**1958 Agreement – Consideration of draft amendments
to existing Regulations submitted by GRE**

Proposal for Supplement 10 to Regulation No. 99 (Gas discharge light sources)

Submitted by the Working Party on Lighting and Light-Signalling*

Figure 1
Category D8R - Cap PK32d-8

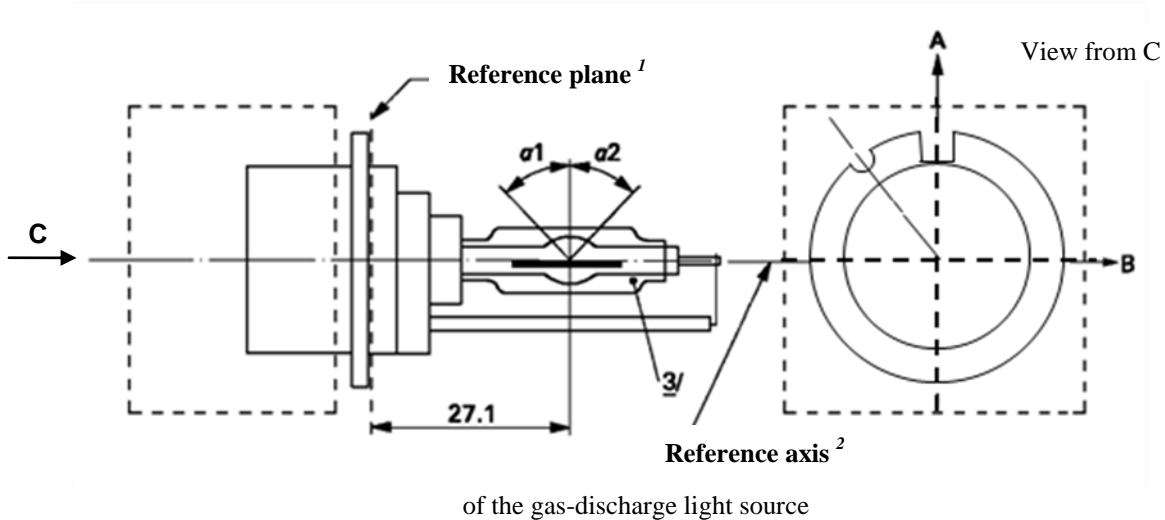
After sheet D8S/5, insert new sheets D8R/1 to 6, to read (see following pages; one page per sheet):

¹ The reference plane is defined by the positions on the surface of the holder on which the three supporting bosses of the cap ring will rest.

² See sheet D8R/2.

³ When measured at a distance of 27.1 mm from the reference plane and with respect to the mid-point of the inner bulb, the outer bulb shall have an eccentricity of 1 mm max.
